SUBJECT: ISSUANCE OF AMENDMENT NO. 9 TO FACILITY OPERATING LICENSE NO.
NPF-74 FOR THE PALO VERDE NUCLEAR GENERATING STATION, UNIT 3
(TAC NO. 67865)

PALO VERDE NUCLEAR GENERATING STATION, UNIT NO. 3

Amendment No. 9
License No. NPF-74

SAFETY EVALUATION BY THE OFFICE OF NUCLEAR REACTOR REGULATION
RELATED TO AMENDMENT NO. 9 TO FACILITY OPERATING LICENSE NO. NPF-74,
ARIZONA PUBLIC SERVICE COMPANY, ET. AL.
PALO VERDE NUCLEAR GENERATING STATION, UNIT NO. 3

FIGURE 3.1-1
 ALLOWABLE MTC MODES 1 AND 2
 PALO VERDE UNIT 3 CYCLE 1

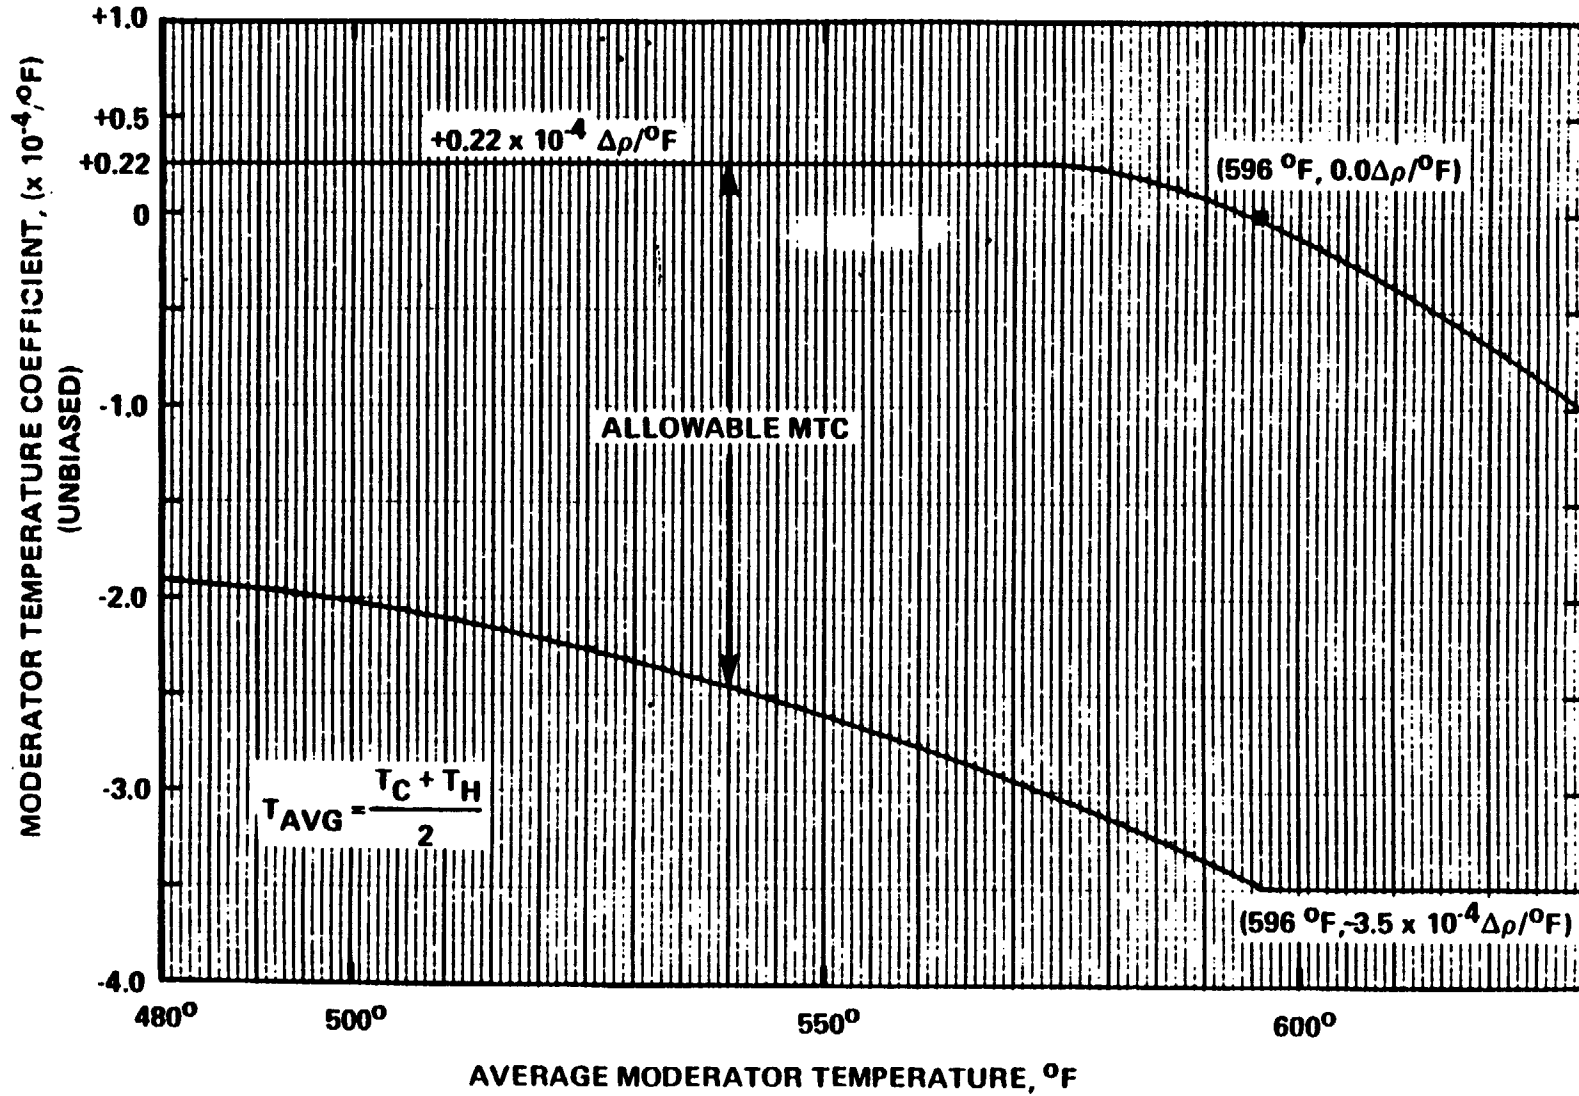
The Amendment revises the Technical Specifications for Palo Verde Unit 3, as follows. Technical Specification 3/4.1.1.3 provides limits on the Moderator Temperature Coefficient (MTC). The Amendment revises Figure 3.1-1 to increase the negative MTC limit from -30 pcm/°F to -35 pcm/°F.

By letter dated April 7, 1988, the Arizona Public Service Company (APS) on behalf of itself, the Salt River Project Agricultural Improvement and Power District, Southern California Edison Company, El Paso Electric Company, Public Service Company of New Mexico, Los Angeles Department of Water and Power and Southern California Public Power Authority (licensees), requested a change to the Technical Specifications for Palo Verde Nuclear Generating Station, Unit 3 (Appendix A to Facility Operating License No. NPF-74). The application requested a change to revise Technical Specification 3/4.1.1.3 by changing Figure 3.1-1 to increase the negative Moderator Temperature Coefficient (MTC) limit from $-30 \text{ pcm}/^\circ\text{F}$ to $-35 \text{ pcm}/^\circ\text{F}$.

The TS limit on MTC was determined from the CE System 80 steam line break analysis. In the analysis, an assumed moderator reactivity versus coolant temperature function was applied using the most negative (including uncertainties) technical specification moderator temperature coefficient of $-35 \text{ pcm}/^\circ\text{F}$ at nominal full power conditions, $T_{\text{avg}} = 594^\circ\text{F}$.

The current MTC limit of -30 pcm/°F in the Unit 3 TS was required to compensate for the as-built safety injection drain line configuration. Subsequently the drain lines were reconfigured so that the MTC limit of -35 pcm/°F that was assumed in the safety analyses would be valid.

Based on the above, the staff concludes that the proposed change to Specification 3/4.1.1.3 is acceptable.
